Village of Itasca

Committee of the Whole Meeting Agenda June 21, 2016

TO: Village President Jeff Pruyn and Itasca Board of Trustees
FROM: Nancy Hill, Community Development Director
DATE: June 16, 2016 for June 21, 2016 Village Board COW Meeting
RE: Relief from Building Code for 400 E. Walnut Street (Itasca County Club)

Subject: Village of Itasca/Illinois Tollway/IDOT/DuPage County/Township of Addison
Intergovernmental Agreement (IGA)
Illinois Route 390 Hamilton Lakes Drive to Arlington Heights Road
Recommendation for Execution of Cost Participation Letter (with conditions)

CONTRACT NO. I-13-4629
 ITS PLANS

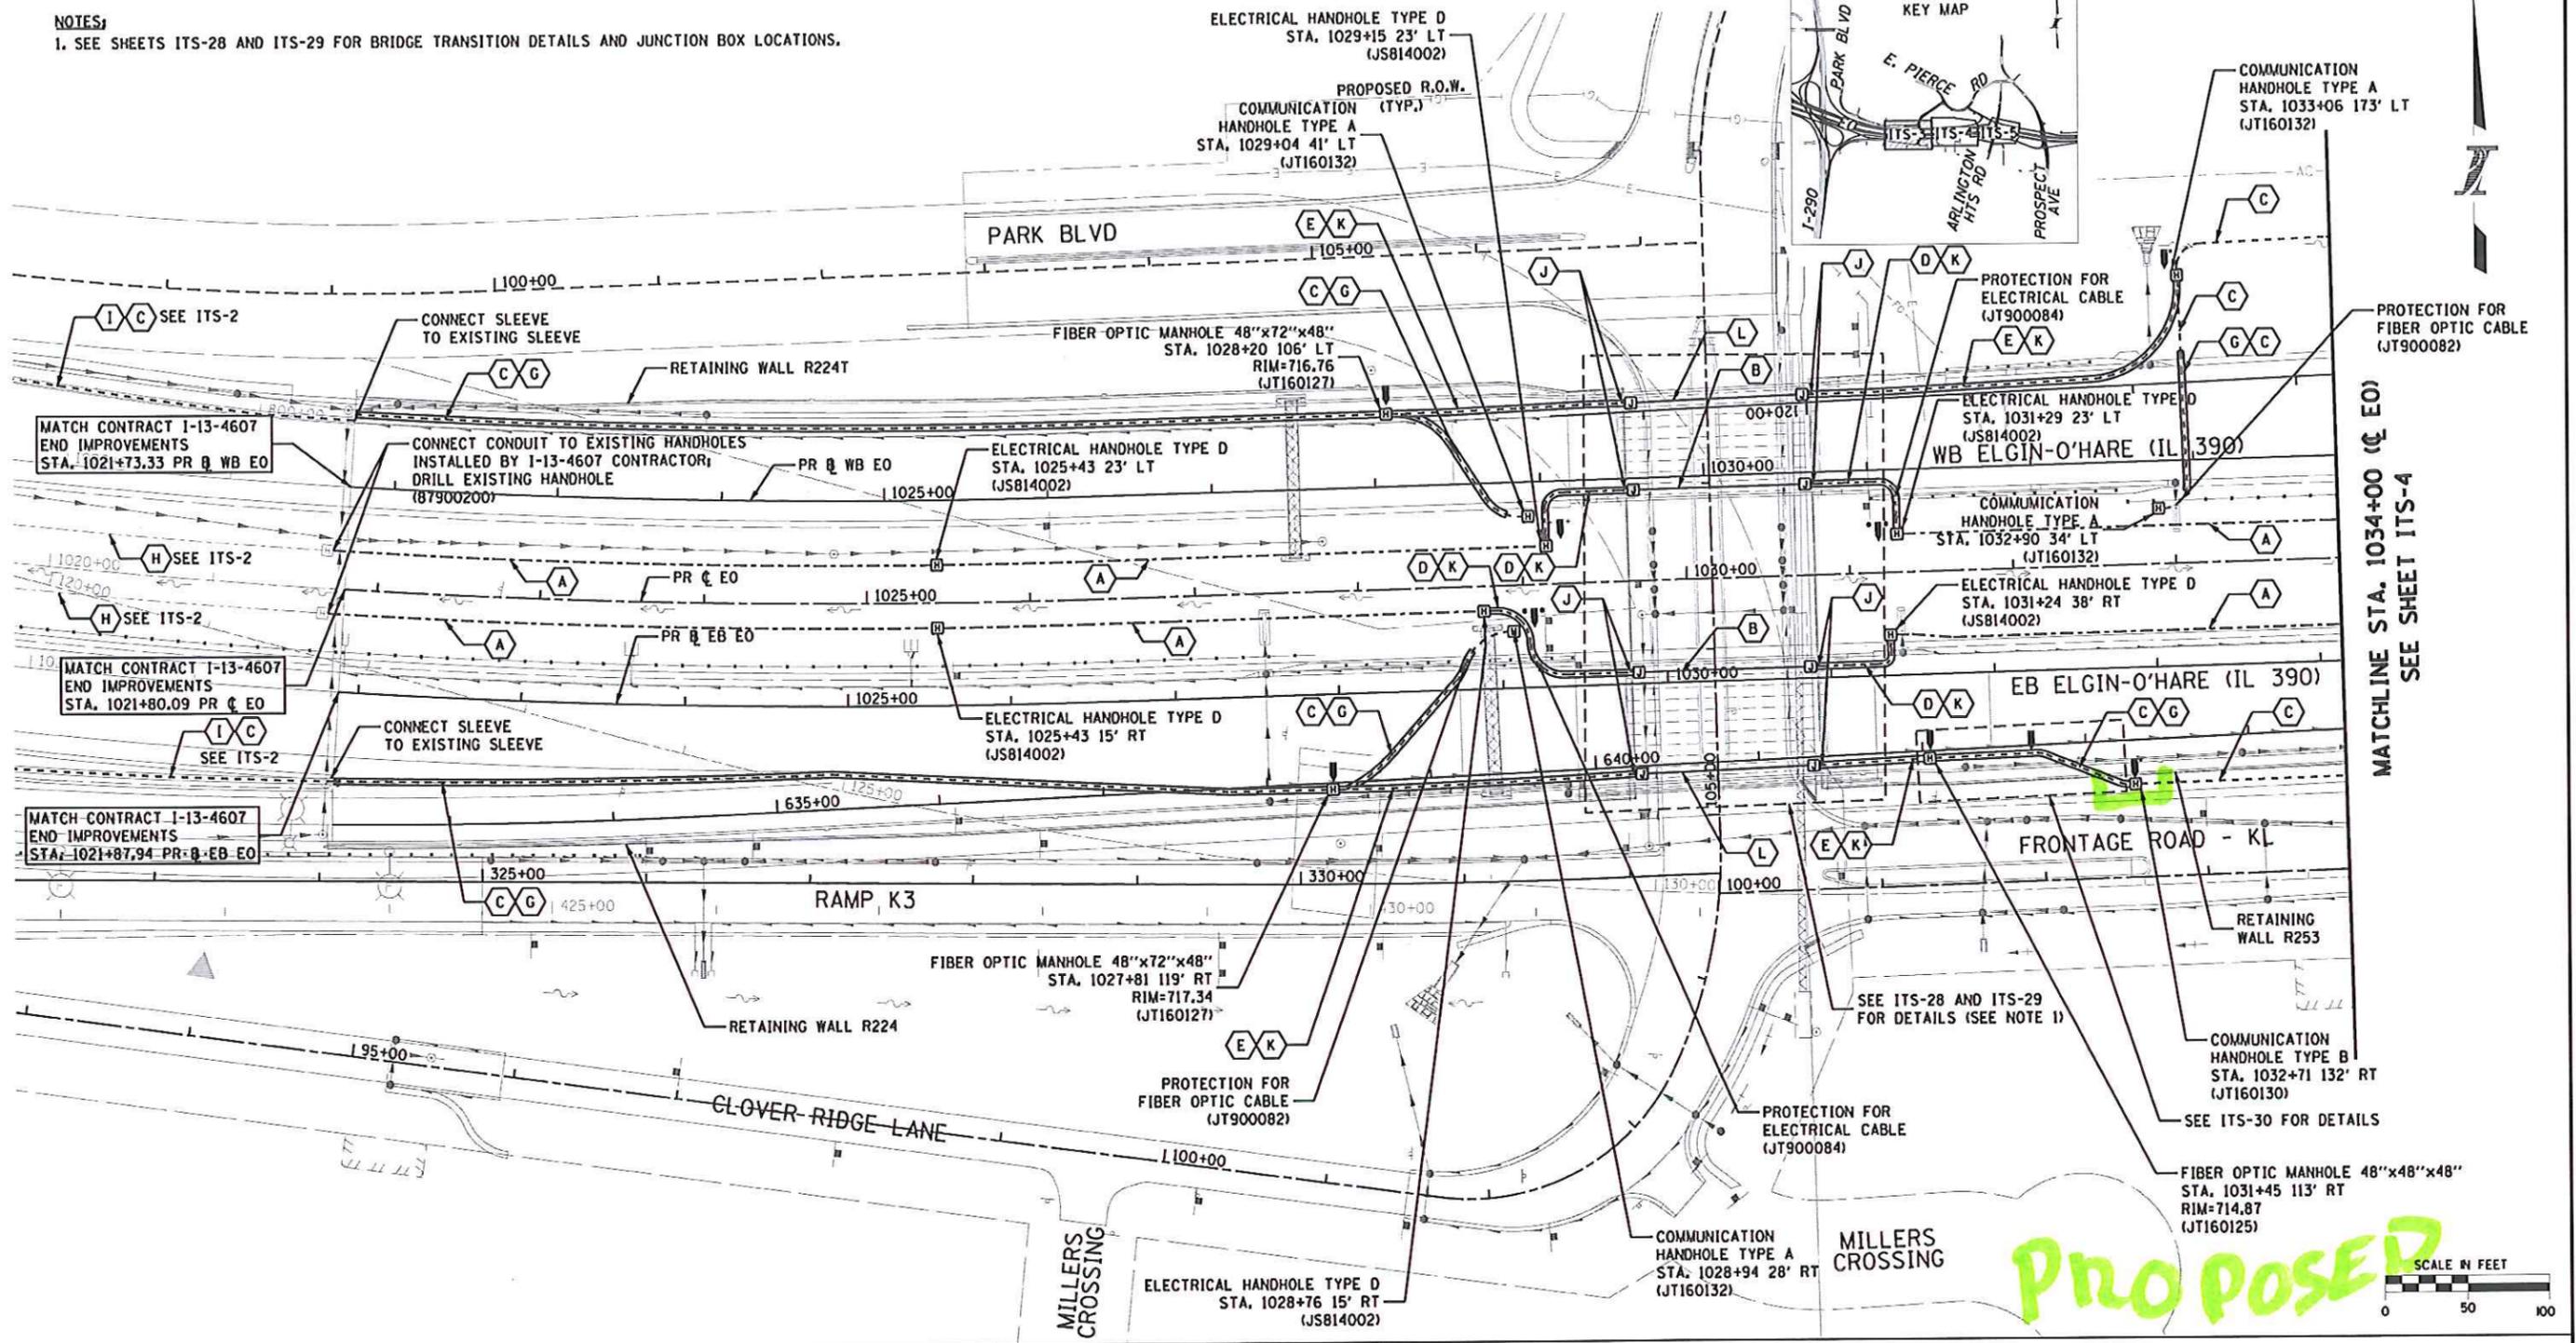
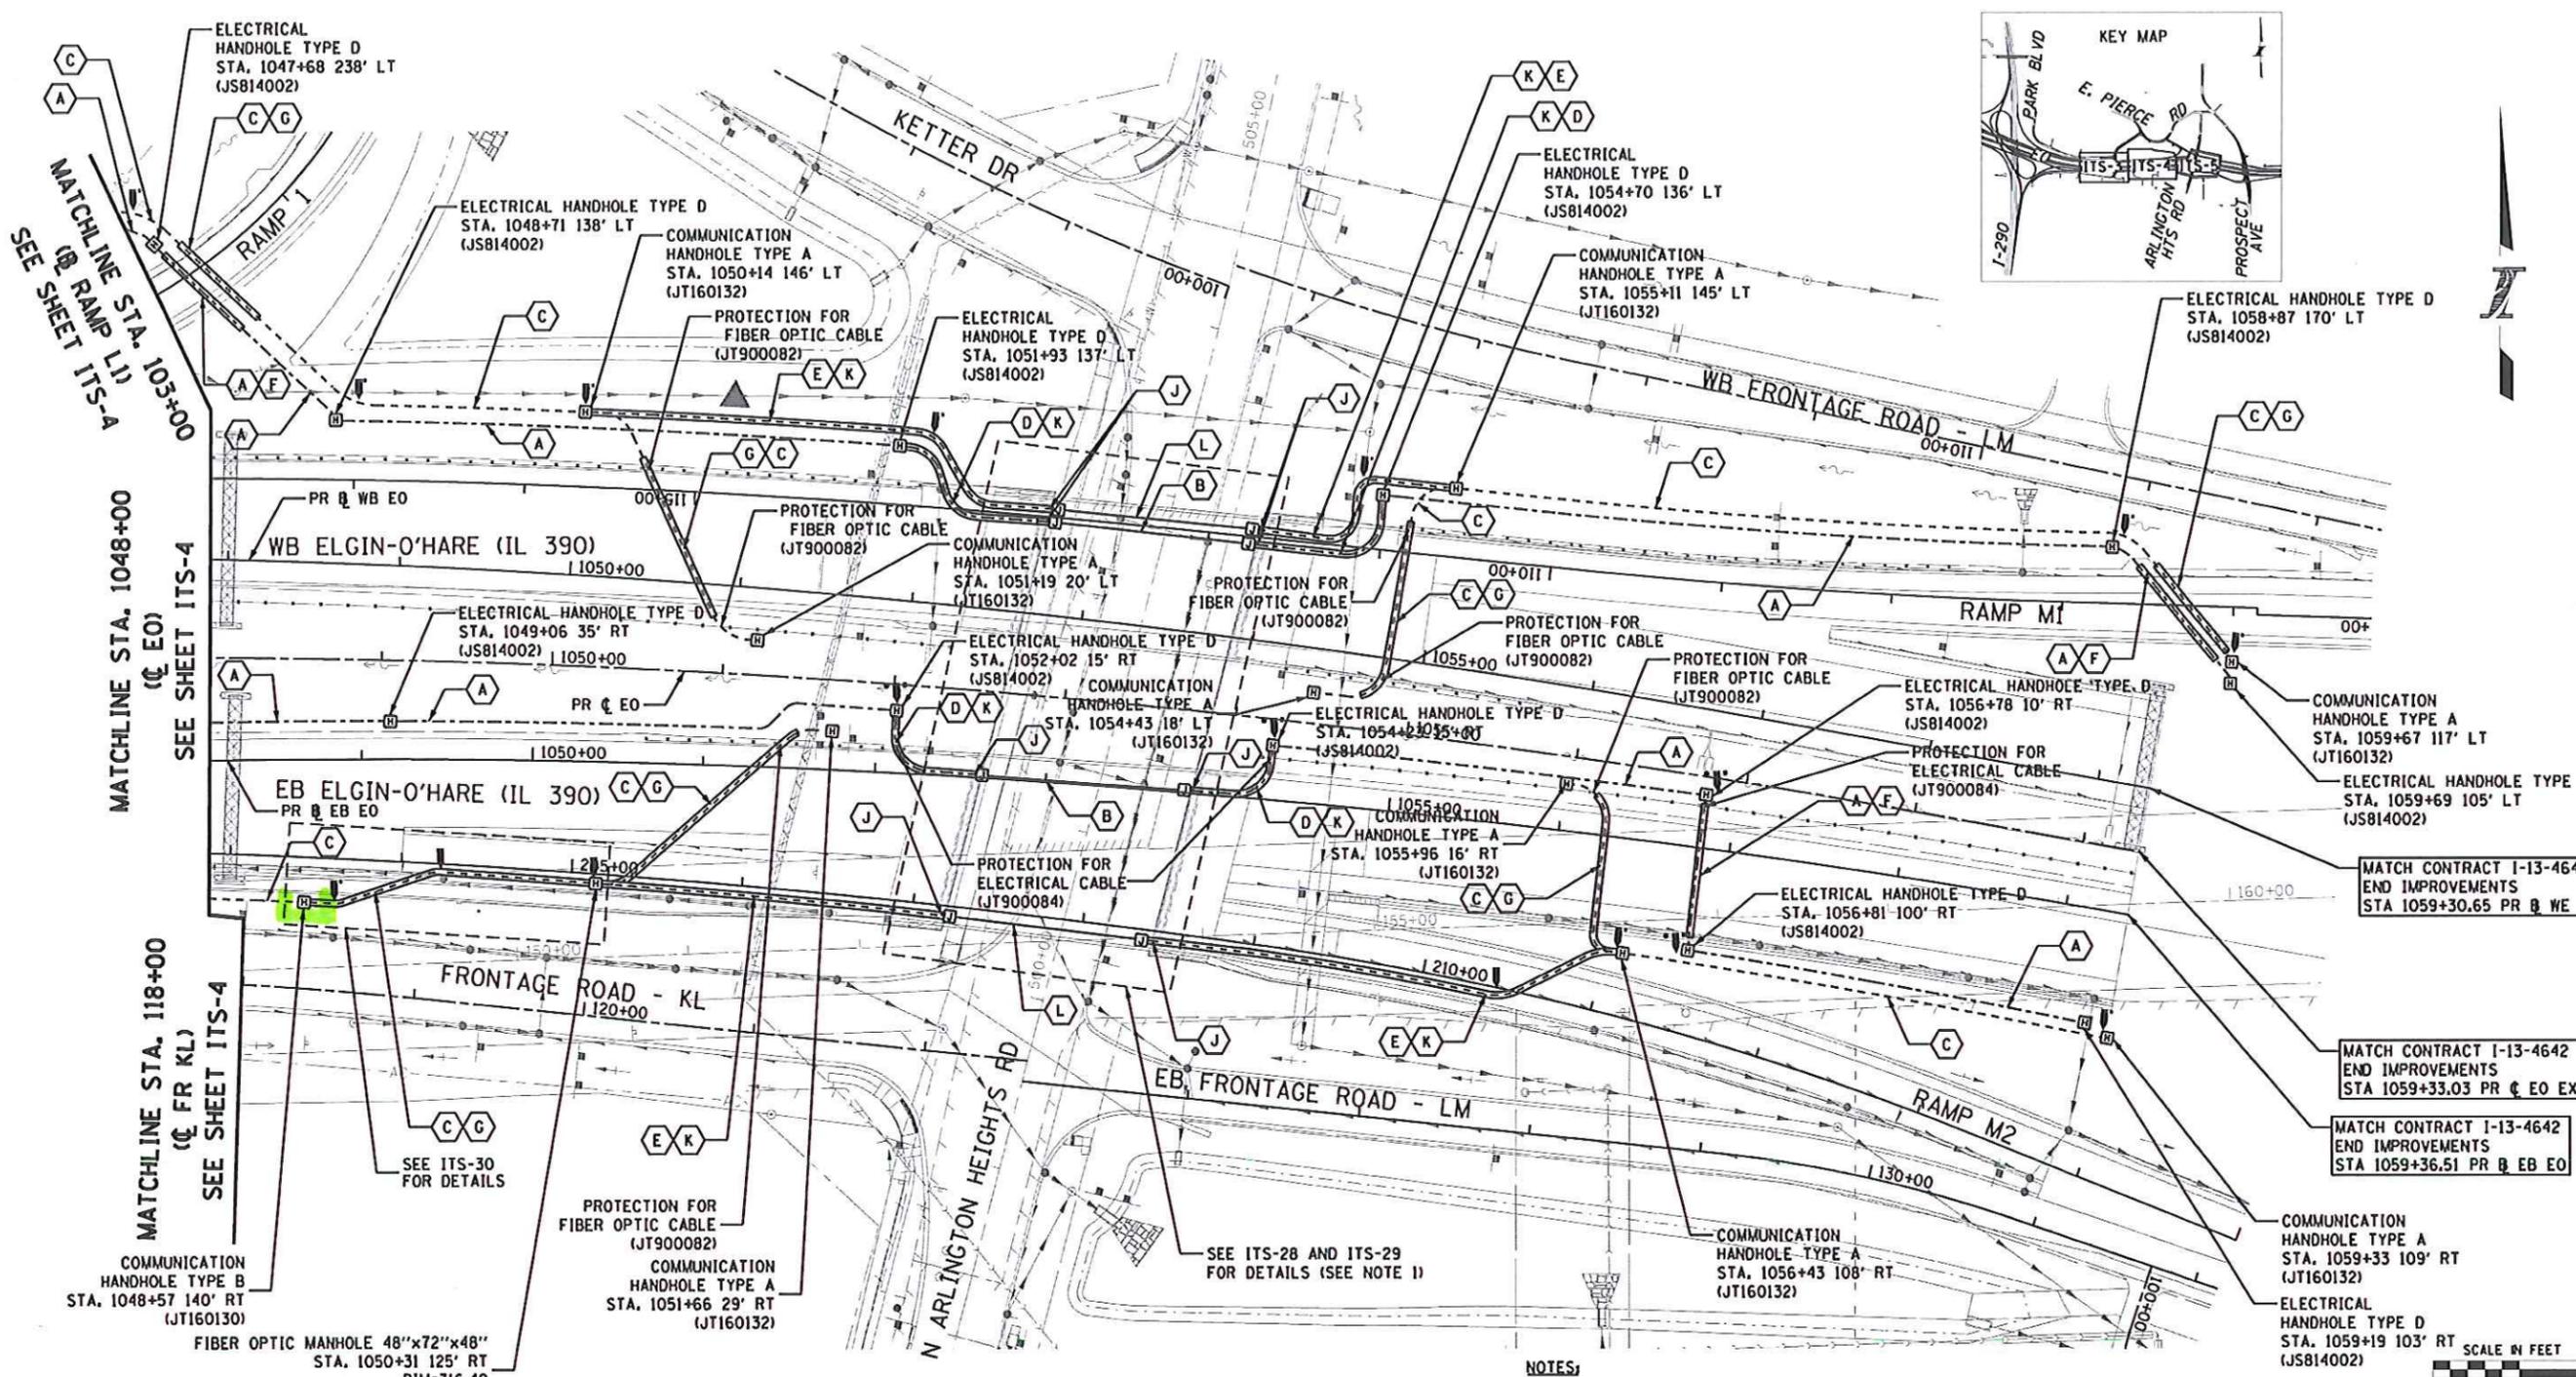
The current design plans include access control fencing between the EB Illinois Route 390 and the South Frontage Road, between Hamilton Lakes Drive and Arlington Heights Road, for a distance of about 2100 feet. This fencing is parallel to the South Frontage Road and is located about 6 feet from the north curb and gutter, and is desired by the Tollway so that their buried ITS fiber optic communications cables and conduits are located within a secured area. Along with the buried ITS conduits are 5 handholes that are constructed flush with the ground surface, which provide access to the ITS system cables.

- I have attached additional design drawings with suggested alternative access control fence segments highlighted in green, which will still provide security for the ITS handholes located in this parkway area. With only five handholes in a 2100 foot distance, this seems to be a viable alternative to provide security for the ITS system while not disrupting the potential landscaping enhancements which could be placed along this route.

- **I recommend that the Village Board consider providing direction to the Mayor to submit a request letter (which I will have drafted by the COW Meeting) to the Illinois Tollway requesting their redesign of the access control fence as shown in the attached exhibit.**
- **I also recommend that the Village Board consider providing direction to the Mayor to sign the attached cost participation letter which the Illinois Tollway has requested in the interim until the IGA can be finalized. This response should include comments that the Village is in agreement with all items of the request letter, except the limits and expense of the access control fencing, due to the requested redesign.**
